TO : Seung Lee – NRC fax 301-415-5369  
FROM : Sergio Steinfeld – Elgems  
CC : Jim Beebe – GEMS fax 414-548-5197

The letter bellow provides the required information you asked in your E-mail of 3/10/99.  
The answers are in bold letters just after your question.  
The following appendices are attached

- page 3-3 & 3-4 of the MG ATC Operation Manual.
  - Sketch drawing named : MG ATC Rod Unit – Removing the Brass Filter
  - Engineering Drawing No. LBL-000424-01 Warning Label

Figure 3-1. Transmission Source Mask

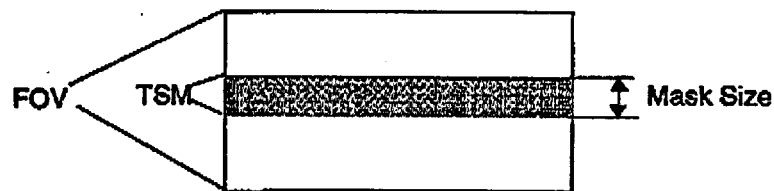
1. Please provide more detailed description for the transmission scan mask on page 3-3 in MG ATC Operational Manual. There are no Figure 3-4 and Table 8-1 as specified. Why is thallium used in example? Is this used in this Rod Unit as a sealed source?

- a) **Attached updated pages 3-3/4 with detailed description for the transmission scan mask. If you are satisfy, let me know and I send you all the updated MG ATC Operation Manual Rev 2.0.**

The transmission scan mask (TSM) defines an acquisition region which moves synchronously with the opposite transmission line source across the detector field of view. (See Figure 3-1)

One of the main purposes of the mask (TSM) is to reduce the crosstalk from the emission isotopes into the transmission image [9]

The transmission image acquires only events which are in the 100 keV energy window corresponding to the  $Gd^{153}$  transmission energy, and also inside the mask (Figure 3-1)

# MG ATC Rod Unit – Removing the Brass Strip Filter

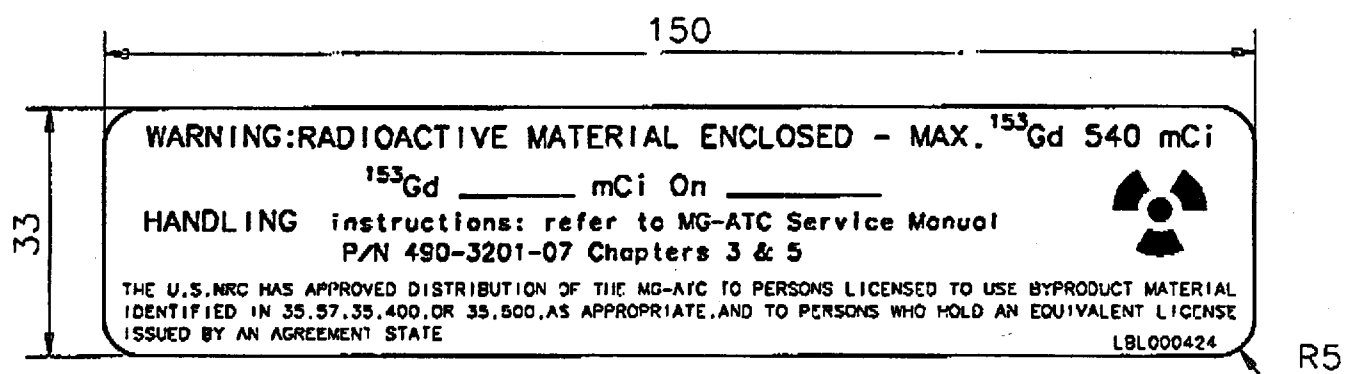
2. In the description of radiation safety feature of device, you stated that "The rod source Gd-153 is sealed with the exposed end having an additional 3.0 mm brass filter strip which reduces the equivalent source activity to 244 mCi for scanning purposes and extends the source life." Please provide the methodology how to extend the source life. How is the brass strip removed and what is its frequency?

**The ATC Rod Unit contains the Gd-153 radioactive source with half life time of 242 days. The initial nominal activity of the source is 450 mCi. At the time of the option installation, an additional 3.0 mm brass filter strip is used, which reduces the equivalent(effective) source activity to 244 mCi for scanning purposes. After approximately one half life time, the filter strip is removed. This allows the full strength of the remaining activity to be used for an additional half life, thus extending the useful life of the source. After one year from the source installation, the source should be renewed and the filter strip is placed back.**

The procedure of removing the filter does not require to disassemble any part of the rod unit and takes a few minutes. The filter is located on the external side of the Rod Unit in front of the collimator (See the drawing attached). During the procedure, the shutter is in its close position. The procedure includes the following simple steps:

- a) Unscrew the locking screw on the rod unit.
- b) Remove the brass strip by sliding it out.
- c) Return and screw the locking screw.

No radiation exposure caused by the procedure. The measured radiation exposure was not exceed 0.0005 mRem, which considered as negligible comparing to background level.
